## Memorandum

**TO:** ERCOT AS Methodology Team

**FROM:** Jeff McDonald, Andrew Reimers

**RE:** IMM Comments on 2026 AS Methodology

**Figure 1: Reserve Requirements Across Various US Electricity Markets**

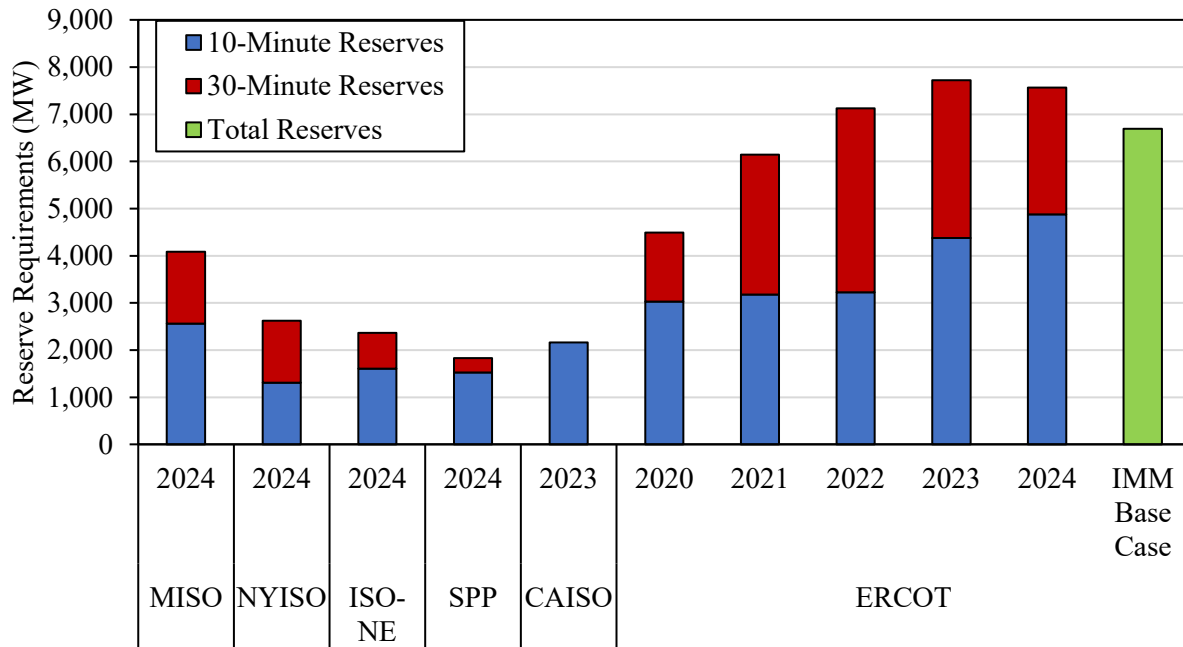
On average, ERCOT procures 153% more 10- and 30-minute reserves than other ISOs.

**Figure 2: Annual Probability of Firm Load Shed and entering Watch Conditions\***

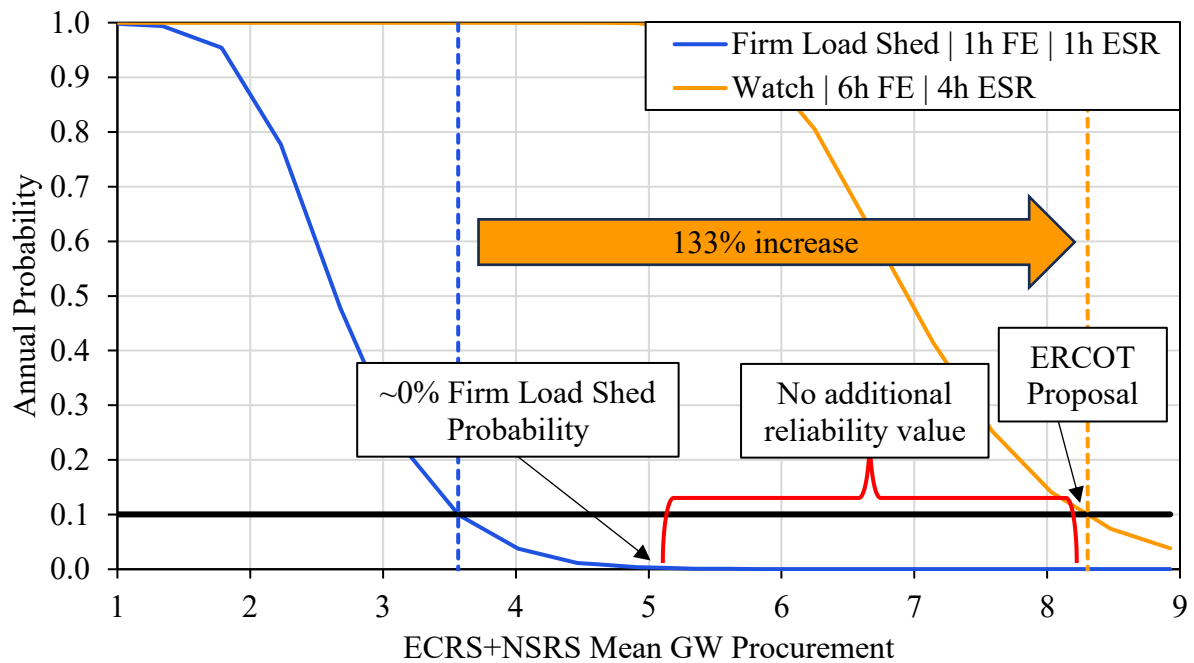
Together, these inputs result in the proposed AS Methodology that procures 133% more than what is required to satisfy the 1-in-10 reliability standard for load shed, *the last 3 GW of which provide no additional reliability*. This is illustrated in the following figure. The blue curve represents the probability of firm load shed at different procurement levels of ECRS and NSRS. This curve reflects the IMM base case and uses a one hour load forecast error and a one hour duration requirement for energy storage resources. The orange curve reflects the probability of entering a Watch condition at different procurement levels of ECRS and NSRS and uses the

ERCOT base case of a six hour load forecast error and a four hour duration requirement for energy storage resources. The procurement level required to achieve a one-in-ten (or 10%) probability of each outcome is identified by the intersection of horizontal black line with these two curves.

This figure shows that the level of total ECRS and NSRS needed to meet the one-in-ten (0.1 probability) reliability standard would average roughly 3.6 GW. In contrast, ERCOT's proposal would procure 8.3 GW of reserves, more than 3 GW of which would have no reliability value.

Together, this AS Plan is 133% larger than the IMM base case which achieves a 1-in-10 yearly probability of load shed. The last 3 GW of this plan provide no additional reliability value on average, as illustrated in Figure 2 (the same figure presented in the executive summary). We recommend that ERCOT revise their AS Methodology and consider operating reserve targets that reflect the reliability value they provide in mitigating real-time operational risks. The remainder of these comments detail our concerns with each of these parameters. A summary of the independent impact of each of these parameters on the size of the AS Plan is included in Table 1 at the end of these comments, and we include portions of Table 1 throughout.

- A 3-hour forecast horizon for determining the target volumes for NSRS.
- Using a 1-in-10 criteria based on the LOLP curve in place of the Watch criteria.
- Using a 1-hour discharge horizon for ESRs rather than 4 hours.

**Figure 3: Annual duration of PRC less than 3,000 MW between 2016 and 2025**

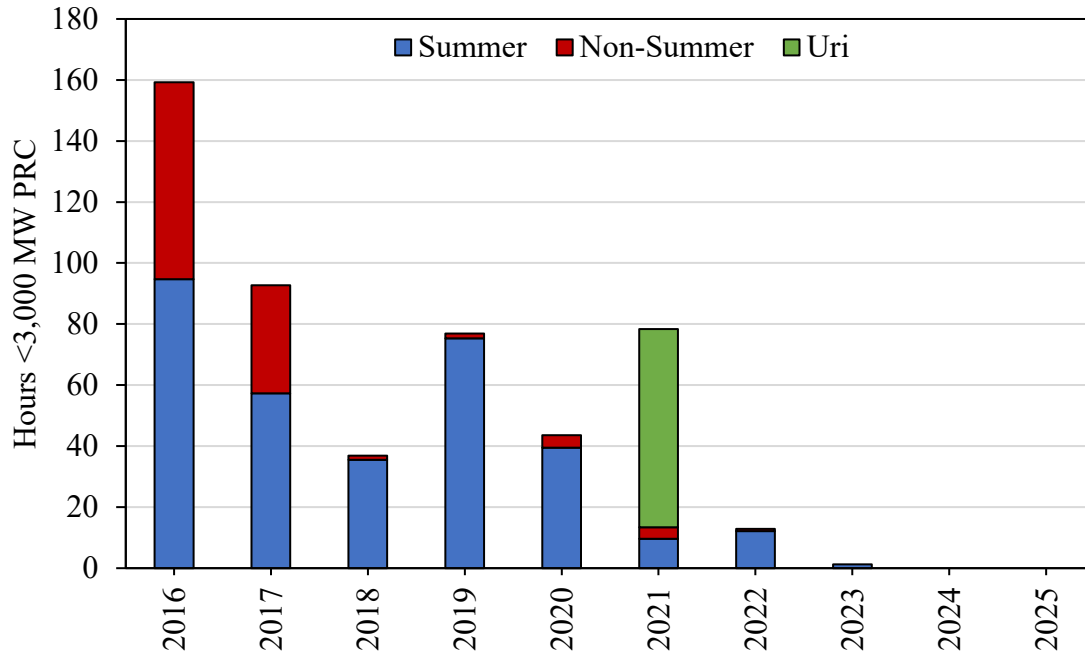
Prior to Winter Storm Uri, ERCOT had a policy of issuing a voluntary conservation notice referred to as a Watch whenever operating reserves dropped below 3,000 MW. Such events

were relatively commonplace, with an average of 82 hours per year with PRC below 3,000 MW for 2016-2020, as shown in Figure 3. The aftermath of Winter Storm Uri shone a spotlight on the reliability of the ERCOT grid and, given the recent legislative session and a gubernatorial election around the corner, it was decided that avoiding Watch conditions was of paramount importance. Thus, Conservative Operations was born, the primary feature of which was to run the system with a high level of operating reserves, whether procured through RUC or through the AS Methodology, as discussed in more detail in the following section.

**Figure 4: Resource Availability Across Response Time Intervals**

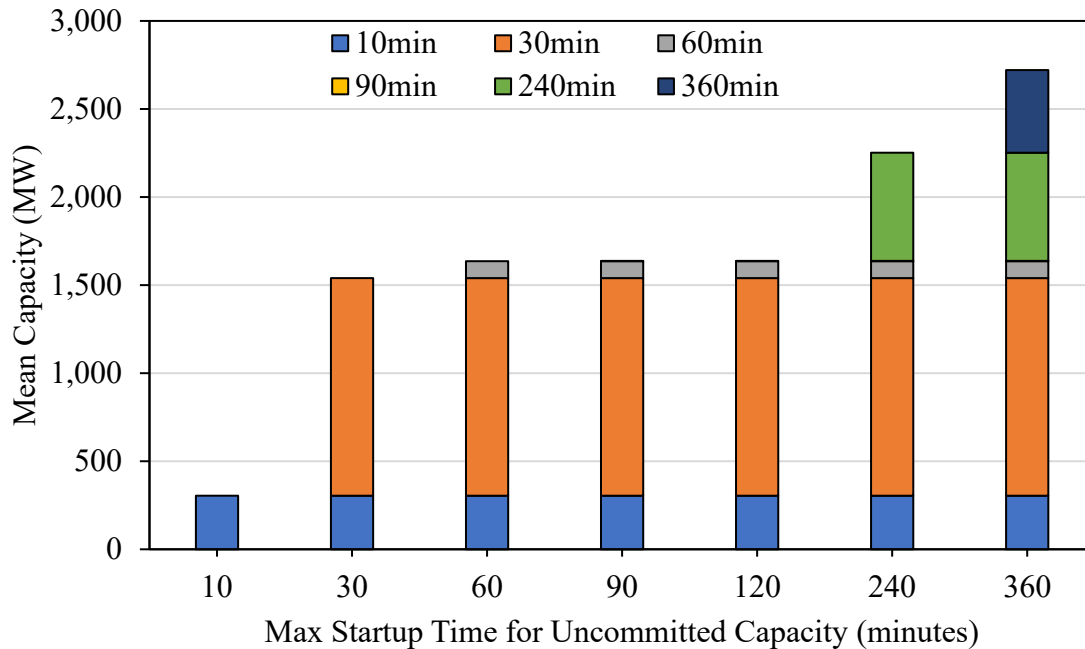
The cumulative capacity of reserves available to start under tight system conditions (PRC < 5,000 MW) includes more than 1,500 MW of capacity capable of starting in an hour or less.

**Figure 5: Net Load Forecast Error Across Different Time Horizon Durations**

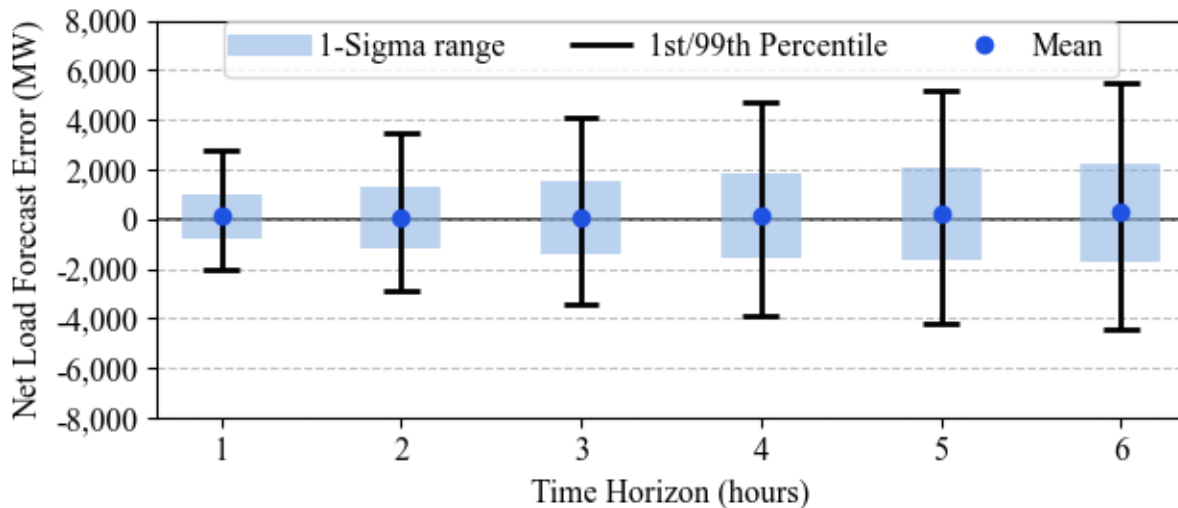
All inputs to the risk assessment should be based on the operational risks that the product is meant to manage. NSRS, for example, is designed to mitigate the risks associated with forced outages or forecast errors over a time horizon of approximately one hour. In the event of such risks manifesting themselves, market pricing should be sufficient to incentivize commitment of offline resources to maintain the reliability of the system. Our analysis has consistently shown that ERCOT has significant capacity from offline reserves that can start in an hour or less under tight system conditions, as illustrated in Figure 4. These conditions produce higher prices which in turn elicit a market response of self-commitment from available off-line resources. Setting this parameter to six hours nearly doubles the perceived risk associated with forecast error, as shown in Figure 5. This parameter effectively assumes that none of the offline capacity will self-commit in response to evolving system conditions, which is contrary to historical experience.

ERCOT's operational history demonstrates that six hours is an unnecessarily long time-horizon to run the system reliably. From 2016 to 2022, the methodology for determining the target volumes for NSRS used a three hour ahead forecast error. Over that time, there was no firm load shed caused by a lack of sufficient NSRS.

**Figure 6: RUC Commitments Between 2016 and 2024**

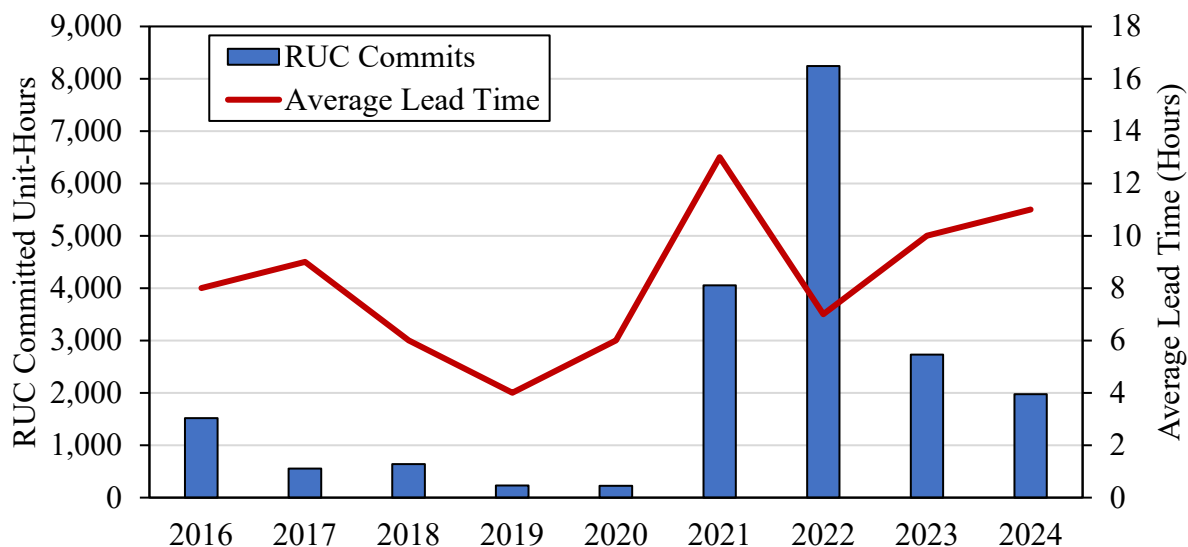
Figure 6 shows the increase in the unit hours of resources committed through RUC and the increase in the average lead time between the commitment instruction and real-time. The following year, to achieve its desired level of operating reserves through the market rather than through overreliance on RUC, ERCOT increased the time horizon used for calculating forecast error in the NSRS methodology to six hours. Thus, *the methodology followed from the operational paradigm*, which itself was not supported by sound reliability criteria.
